F-723-001

Revision: A

2. PCB layout differs but still fits on old layout

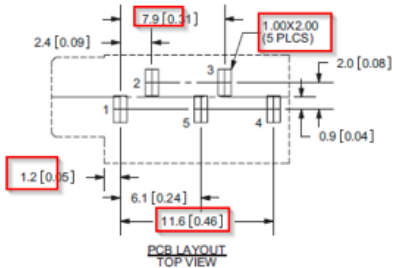
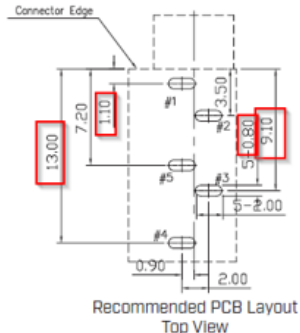
PREVIOUS CUI DEVICES DETAIL / IMAGE	NEW CUI DEVICES DETAIL / IMAGE
